Well Name: SAN JUAN 30-5 UNIT	Well Location: T30N / R5W / SEC 17 / NWSW / 36.809143 / -107.385712	County or Parish/State: RIO ARRIBA / NM
Well Number: 47	Type of Well: CONVENTIONAL GAS WELL	Allottee or Tribe Name:
Lease Number: NMSF078994	Unit or CA Name: SAN JUAN 30-5 UNIT--DK	Unit or CA Number: NMNM78419B
US Well Number: 3003921070	Well Status: Producing Gas Well	Operator: HILCORP ENERGY COMPANY

Type of Submission: Notice of Intent	Type of Action: Plug and Abandonment
Date Sundry Submitted: 04/11/2023	Time Sundry Submitted: 06:34
Date proposed operation will begin: 05/01/2023

San Juan 30-5 Unit 47

NOTICE OF INTENT TO PERMANENTLY ABANDON

San Juan 30-5 Unit 47 - PROPOSED P&A SCHEMATIC

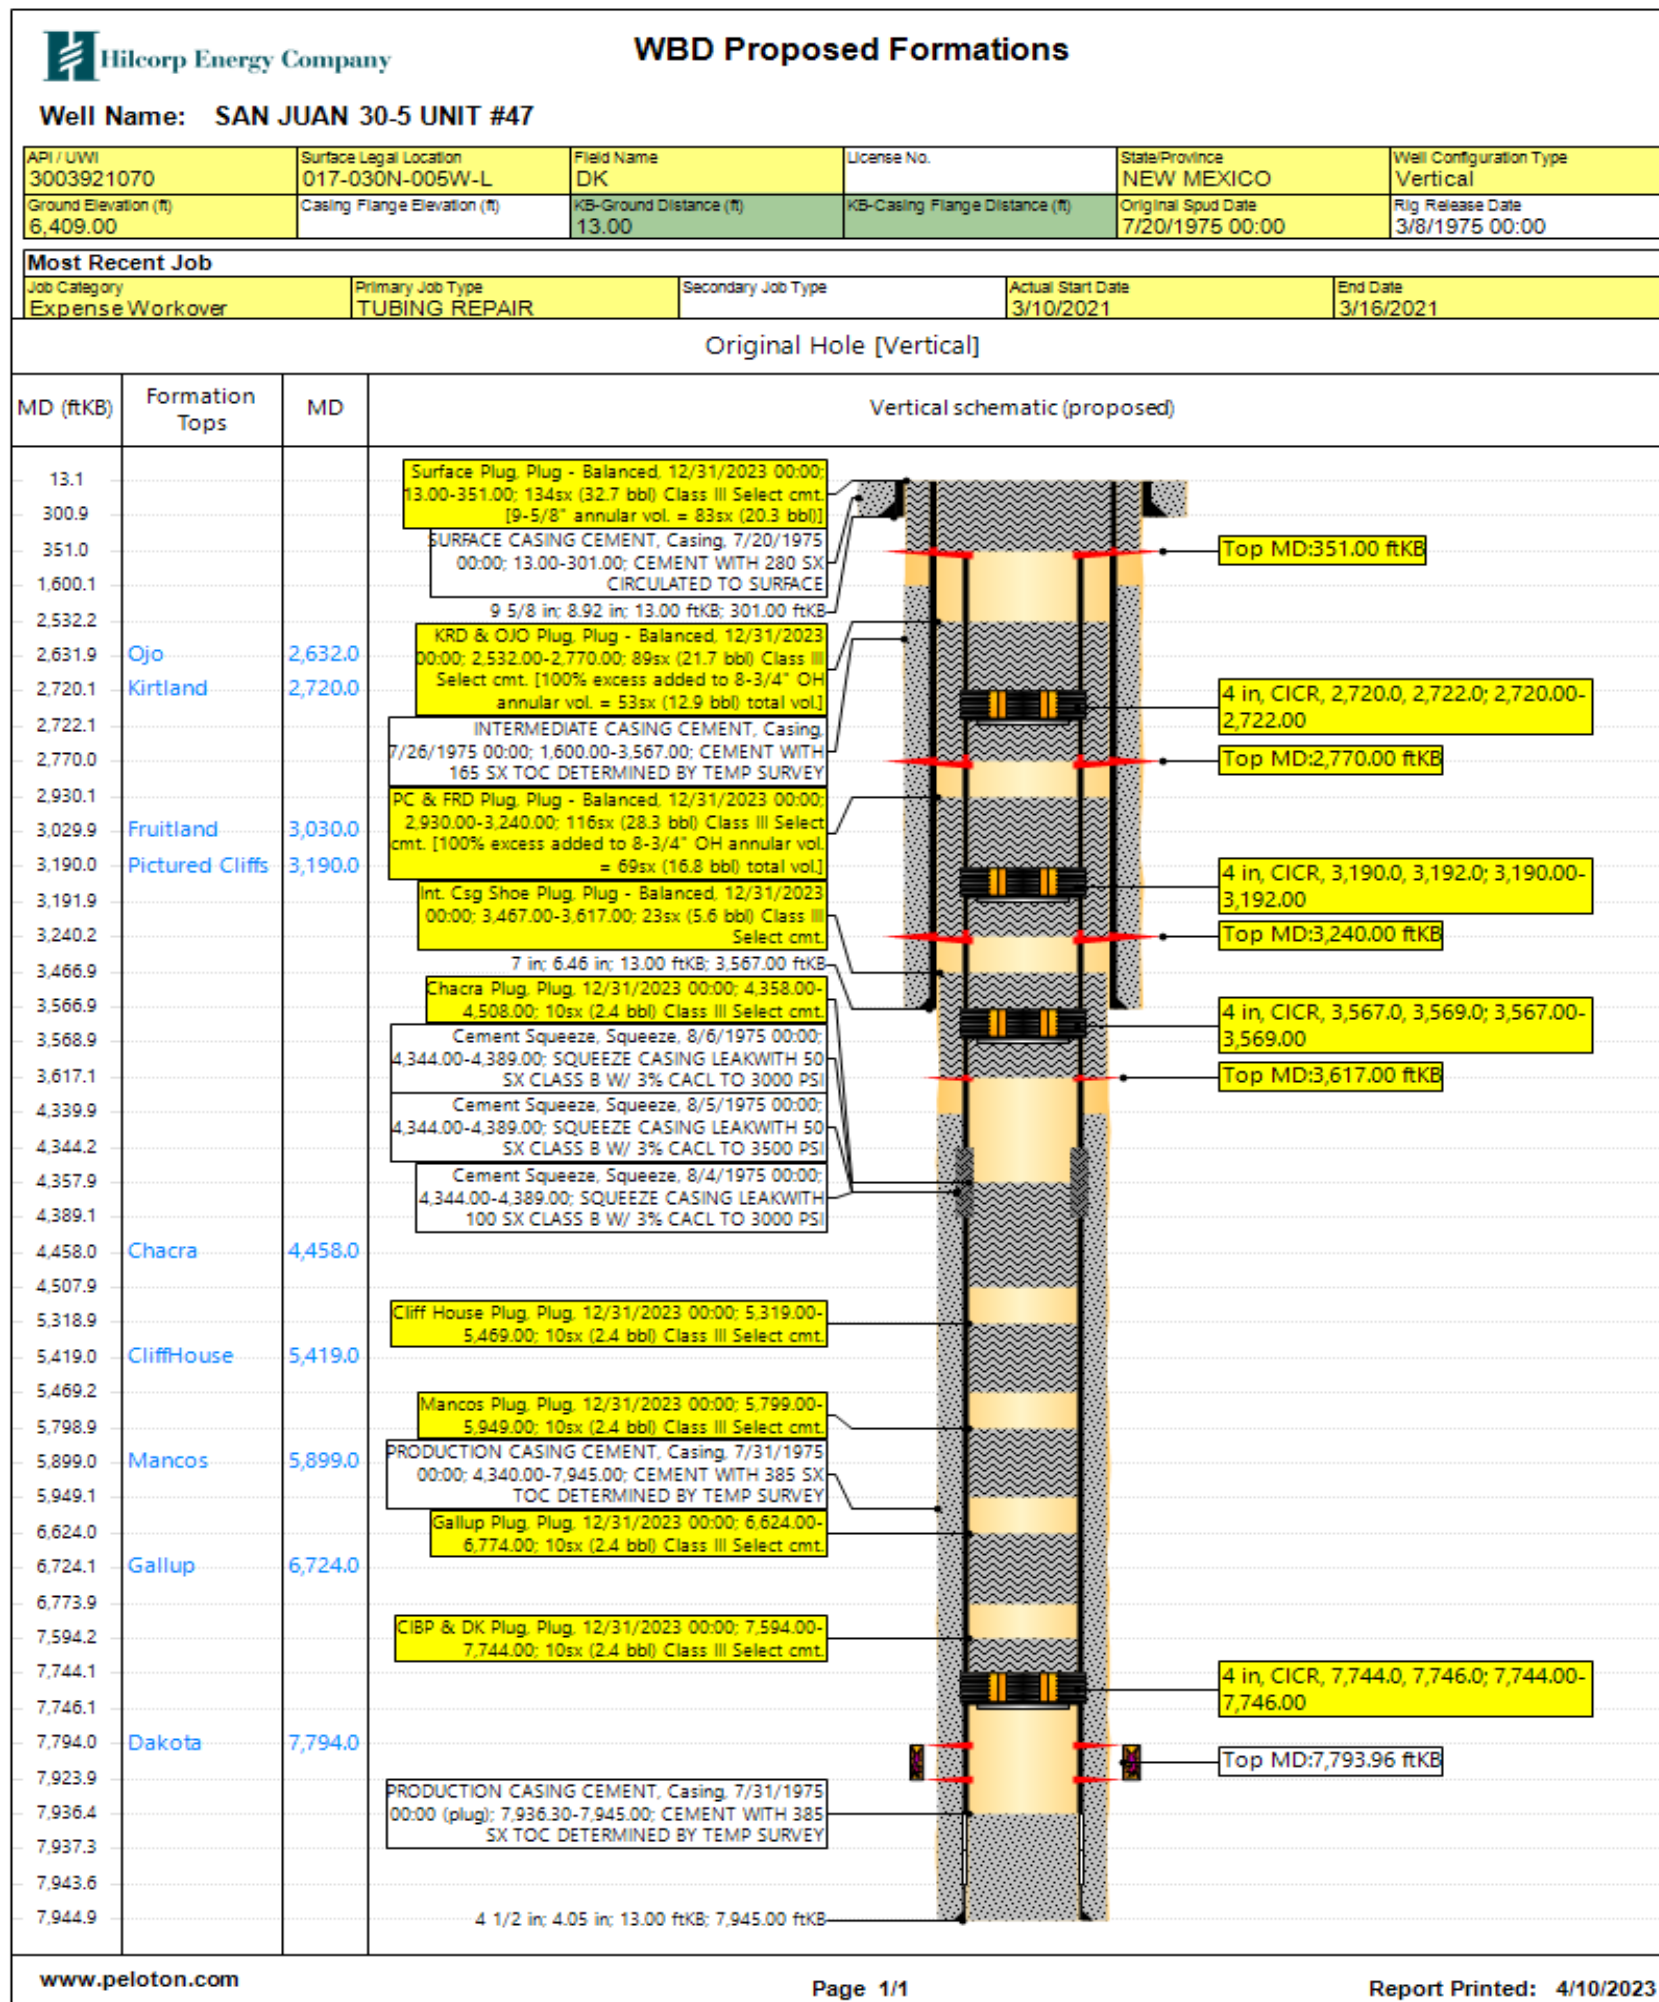
- Add an inside/outside plug to cover the Nacimiento formation top at 1101'.

1. Plugging operations authorized are subject to the attached "General Requirements for Permanent Abandonment of Wells on Federal and Indian Lease."
2. The following modifications to your plugging program are to be made:
 - a. Add an inside/outside plug to cover the Nacimiento formation top at 1101'.
3. Farmington Office is to be notified at least 24 hours before the plugging operations commence at (505) 564-7750.
